Sheet	Number
First sheet	1/1
Project	Revision
Electronic Load	1
Drawn by	
Kenneth	
Date	
2022-07-26

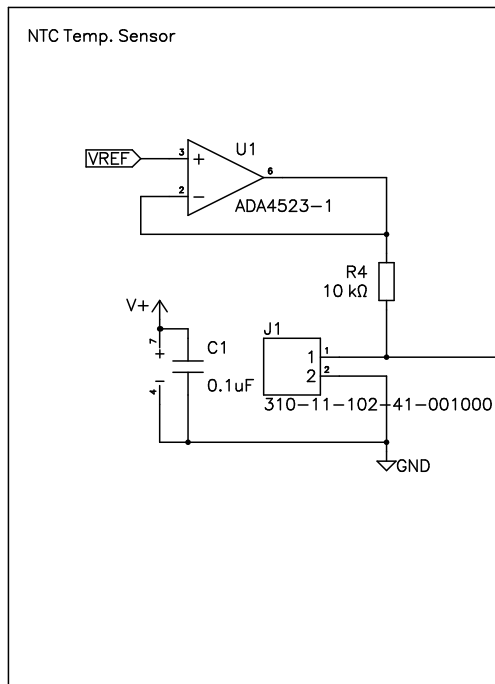
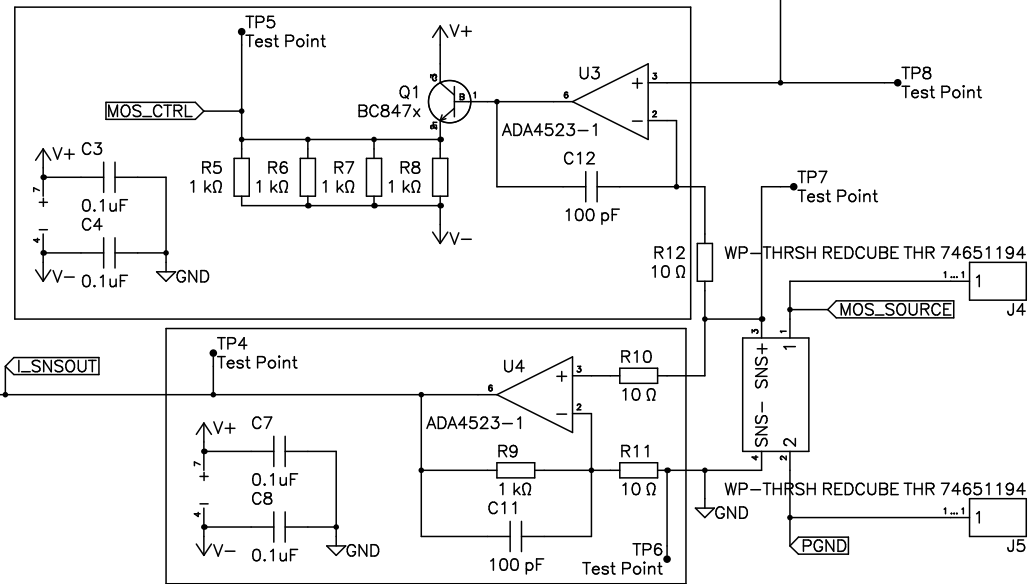
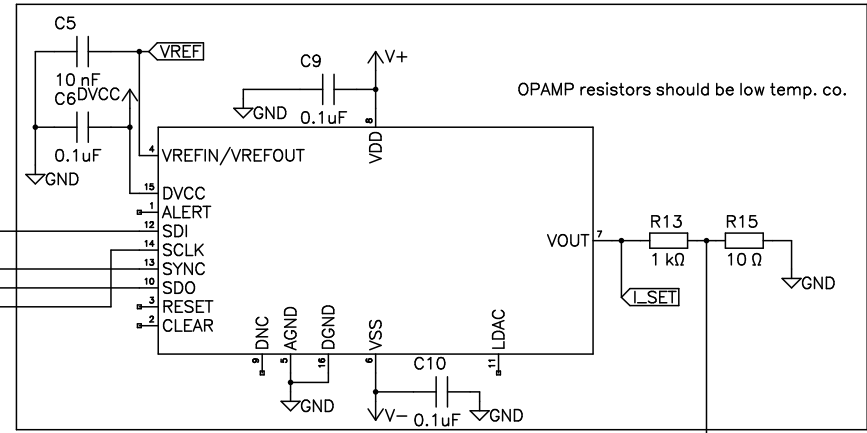
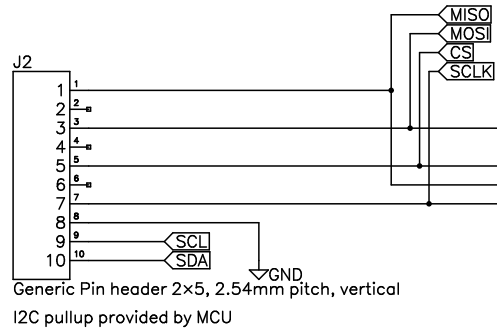
Power and communication busses will come from separate board

replace ads1115 with ads1118

add differential input for channel voltage measurement

DVCC should be 5 volts to allow adc to measure 5 volts

level shifter for spi on digital board

5V/DVCC should be isolated output

fan control must be done with optocouplers
